AP1000 DESIGN CERTIFICATION REVIEW

Response to Request For Additional Information

RAI Number: 720.088

Sketch A-1

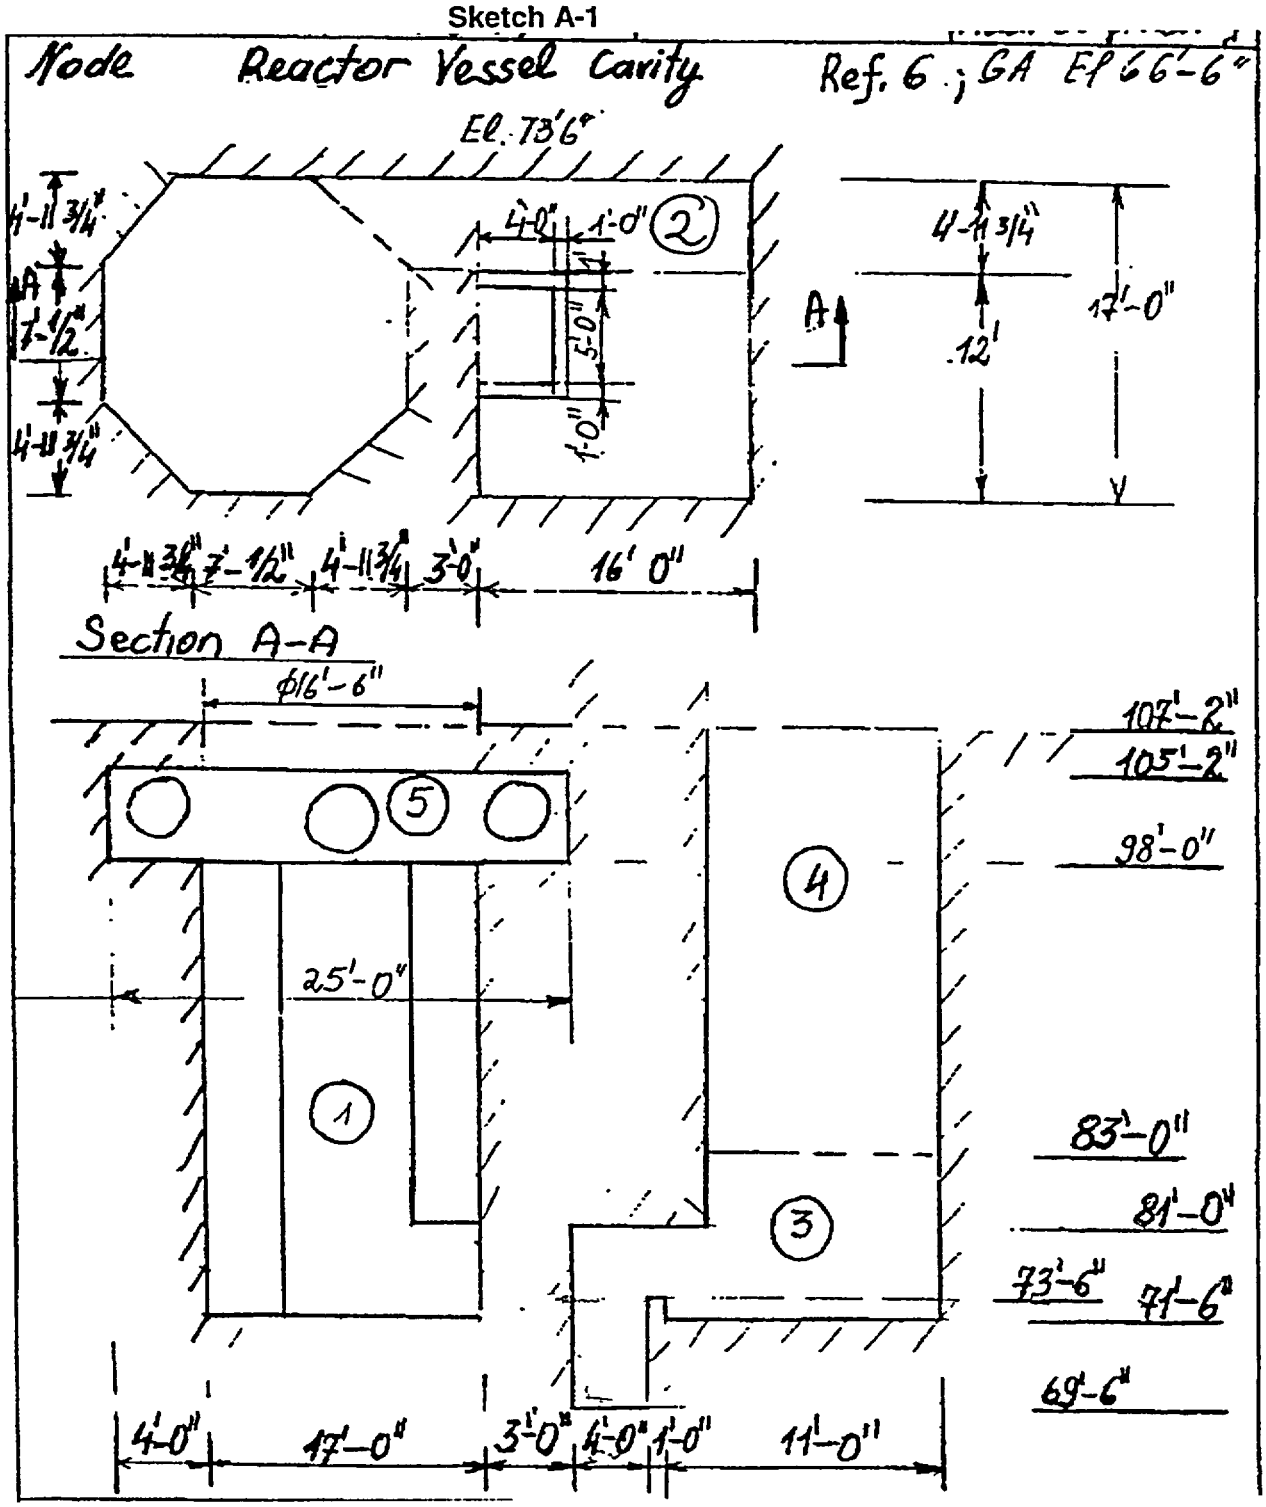
Please provide values for the following AP1000 parameters needed to complete the MELCOR input deck (this list includes parameters that were not addressed in response to RAI 720.001 dated September 10, 2002).

A. Westinghouse letters DCP/NRC1513 dated July 24, 2002, and DCP/NRC1533 dated November 22,2002 transmitted proprietary drawings that provide most of the dimensional information requested in this RAI. The attached table A-1 provides a response to the 24 items requested, and identifies that information that can be found in these transmittal letters.
